BHARAT HEAVY ELECTRICALS LIMITED
PROJECT ENGINEERING MANAGEMENT, NOIDA

CORRIGENDUM- 02

PROJECT	:	3x800 MW PVINL PATRATU TPP PHASE-1
PACKAGE	:	FUEL OIL HANDLING AND STORAGE SYSTEM
ENQUIRY NO	:	PE/PG/PA1/E-6419/2020 Dated. 08.04.2020
SUBJECT	:	PRE- BID CLARIFICATION

PRE BID CLARIFICATION SCHEDULE				
Project:	3 x 800MW PVUNL PATRATU TPP PHASE-1			
Package:	FUEL OIL UNLOADING AND STORAGE SYSTEM			
Sr.No.	Section/Clause/ Page No.	Statement of the referred clause	Clarification/ Confirm action required	BHEL REPLY
A	Mechanical			
1	P&ID for HFO, LDO and Steam & condensate system, Drg. No. PE-DG-434-166-A001, Rev.00 / Page no. 343 to 347 of 606. Piping layout in & around storage tank farm area, Drg.no. PE-DG-434-166-A004 Piping layout of unloading pump house, Drg.no. PE-DG-434-166-A004	Refer pipe sizes in the P&ID's and Piping layouts	Sizes of following lines shown in the P&ID's are contradicting with the sizes indicated in the Piping Layout drawings. HFO rail wagon unloading header Suction & discharge headers of HFO unloading pumps HFO supply line to pressurizing pumps HFO inter tank transfer line HFO return line from Boiler LDO supply line to pressurizing pumps LDO inter tank transfer

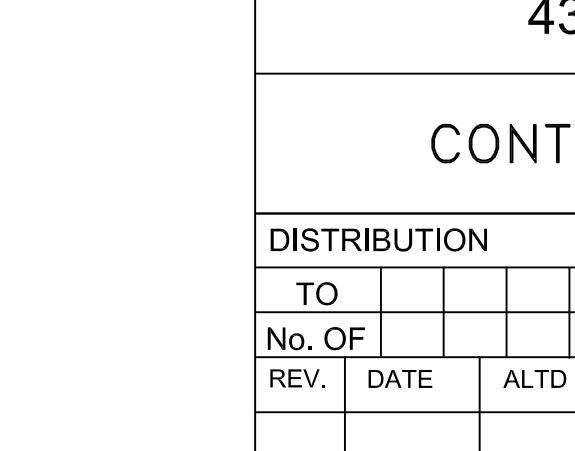
2	P&ID for HFO & LDO system, Drg. No. PE-DG-434-166-A001, Rev.00, Sht. 02 of 06. / Page no. 343 of 606.	Regarding the location of suction line tapping on unloading header	From the P&ID we understood that tapping for suction line of HFO unloading pumps shall be taken from the mid length of the unloading header and not from the nearest point on the unloading header from the unloading pump house. Please confirm.	Tapping for suction line of HFO unloading pumps shall not be taken from the mid length of the unloading header. In piping layout of unloading pump house (page no. 355/606) , entry of suction header has been shown. Same shall be extended upto unloading header. Please refer plot plan.
3	Plot plan, Drg. No. PE-DG-434-100-M001 / Page no. 359 of 606.	---	As the size of the plot plan is very high, it's been taking lot of time and experiencing difficulty in navigating between the facilities of FO system in the plot plan of the entire plant. Hence we request to provide plot plan that contains only the facilities of FO system.	Bidder to follow Plot plan provided with specification ,extract of plot plan is attached.

5	Process & Instrumentation Diagram for HFO System Drg. No. PE-DG-434-166-A001, Rev.00, Sht. 02 of 06.	Regarding insulation thicknesses	In the referred P&IDs all pipe line is provided with 50mm insulation thickness in the pipe nomenclature. Whereas based on the temperatures & pipe sizes and service the insulation thicknesses will change. Please clarify whether we have to proceed as per our sizing calculations or as per P&ID.	Insulation thickness shall be as per calculation.

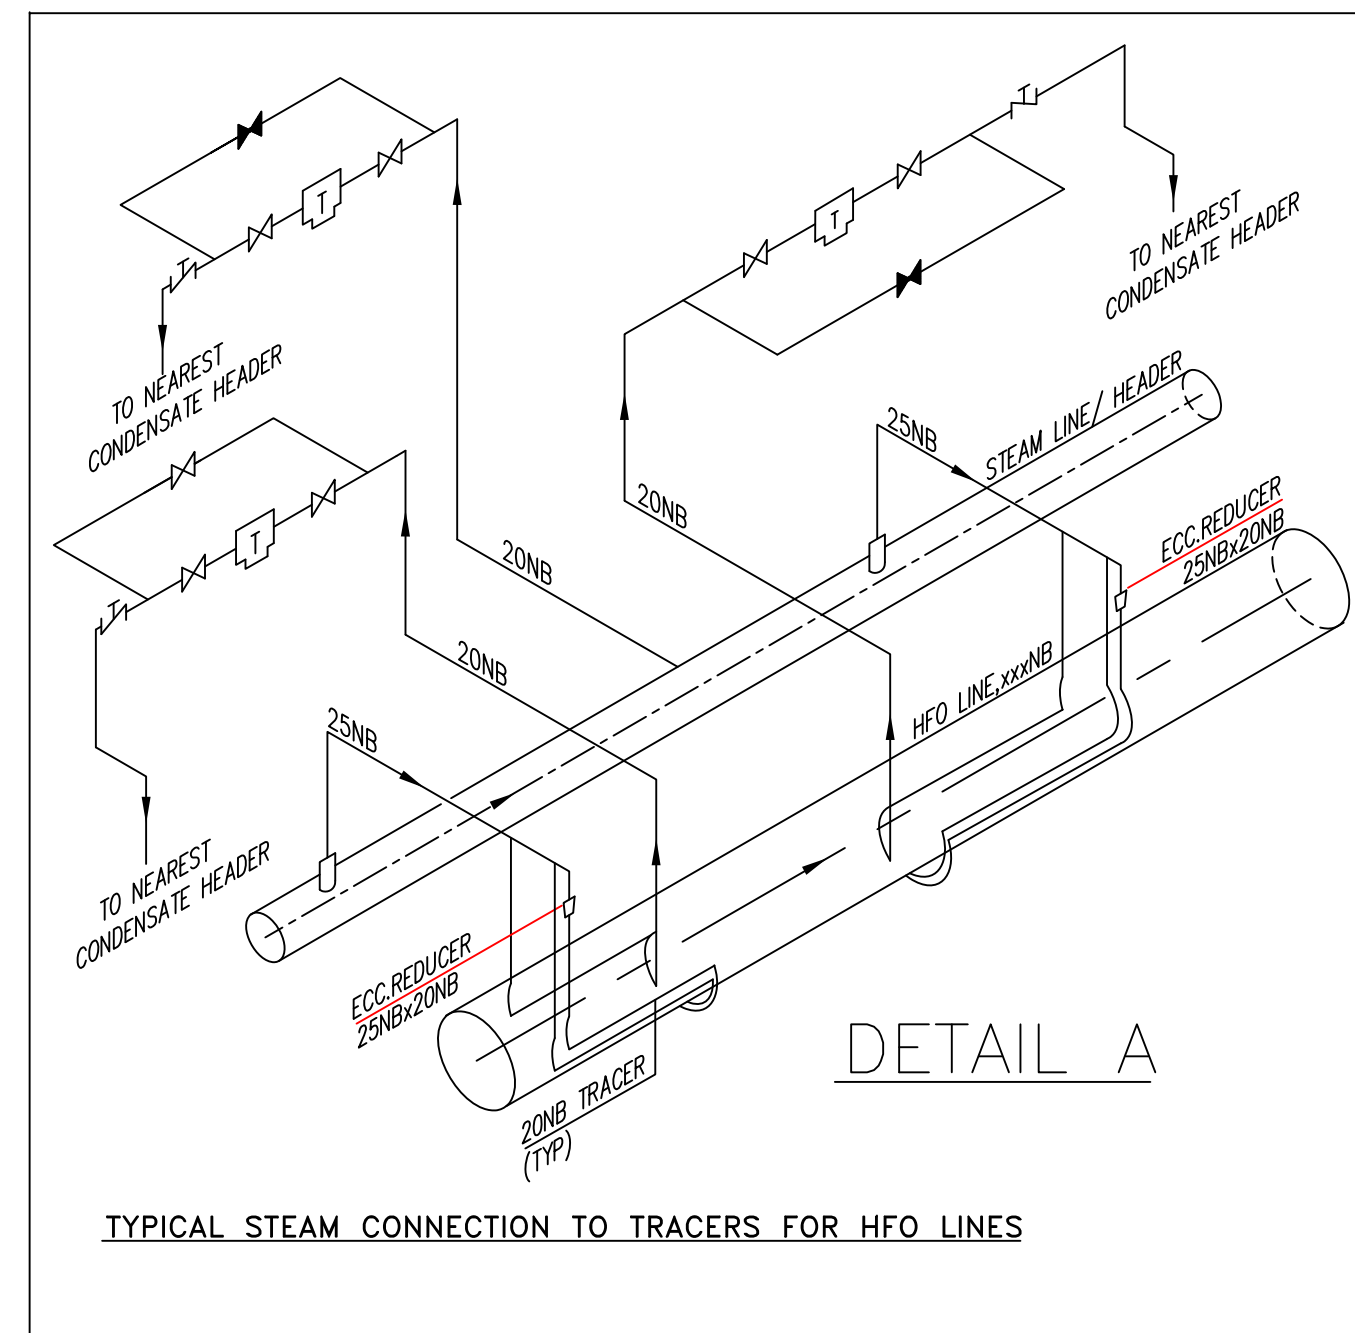
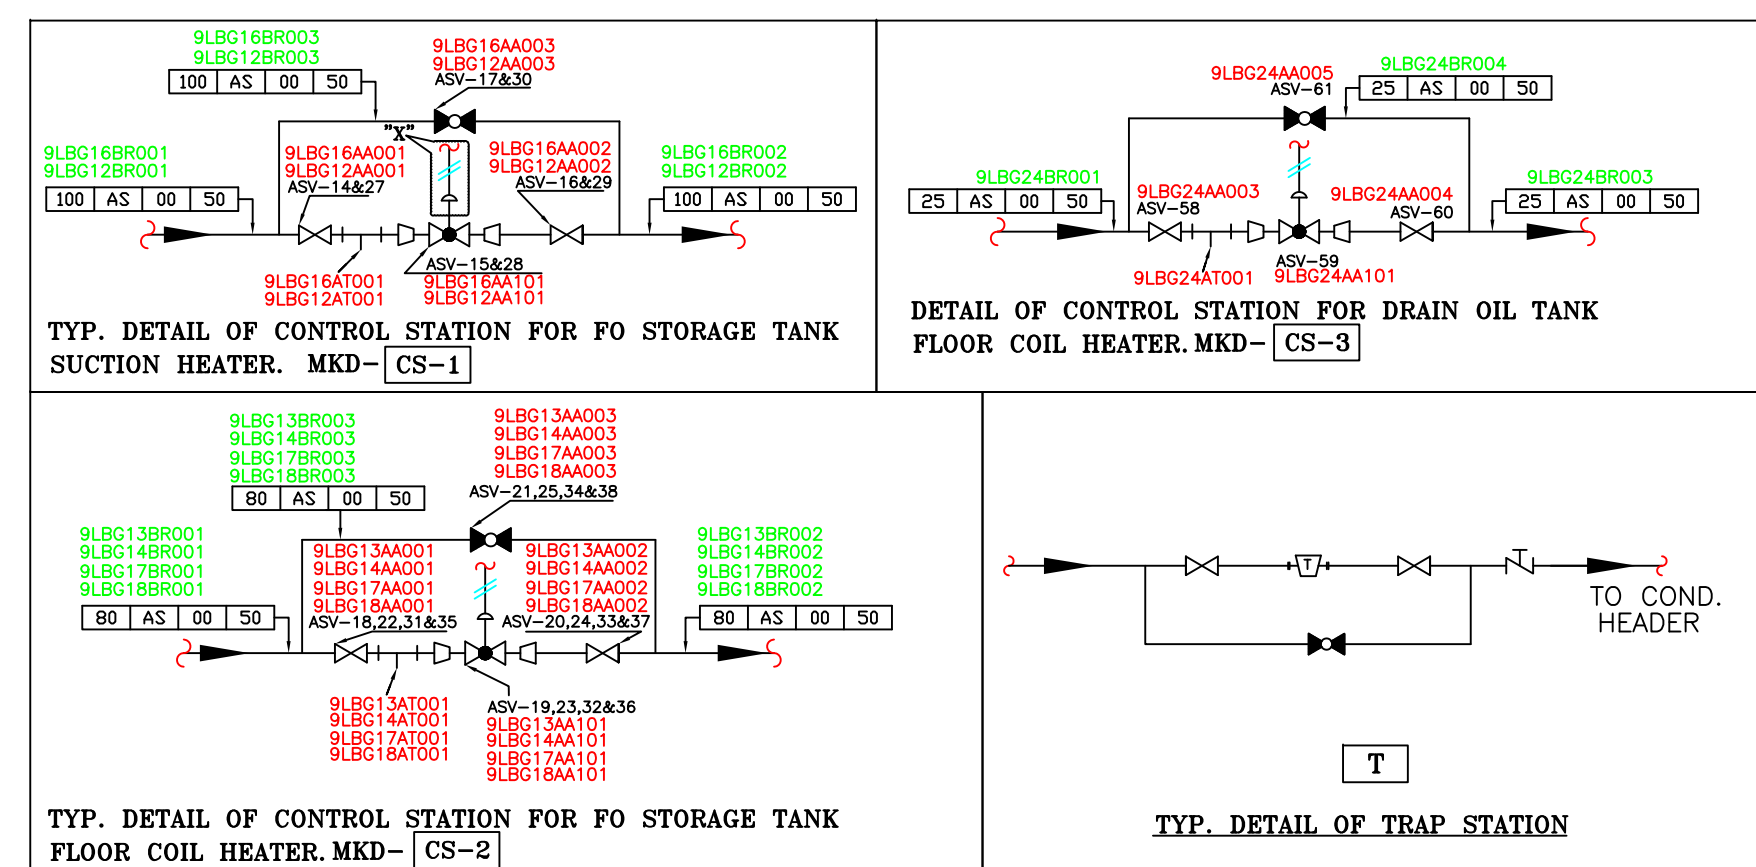
Process & Instrumentation Diagram for HFO System & Steam and condensate Drg. No. PE-DG-434-166-A001, Rev.00, Sht. 02 & 06 of 06.	For redundancy		
7	SECTION-C, C & I TECHNICAL SPECIFICATION FOR DCS BASED FUEL OIL UNLOADING & STORAGE SYSTEM, SPECIFIC TECHNICAL REQUIREMENTS (C&I) WITH SCOPE OF SUPPLY, Page 440 of 606	20) The PDBs (in bidders scope) provided for distribution of UPS loads shall be as per following guidelines. Each PDB shall be provided with input feeder monitoring through potential free contact wired to DCS. The output feeders from the PDB shall be provided with separate fuse & MCB's. 10% spare feeders (min. 1 no.) with MCB & fuses for each rating shall be provided in Bidder's each PDB.	As there is no UPS, UPS ACDB or DCDBs involved in our scope, this clause is not applicable. Please confirm.	The specification requirement is clear. The purpose of this clause is that if any power is required for Equipment/instrument supplied by bidder, BHEL will provide the power at single point. Further distribution is in bidder's scope.
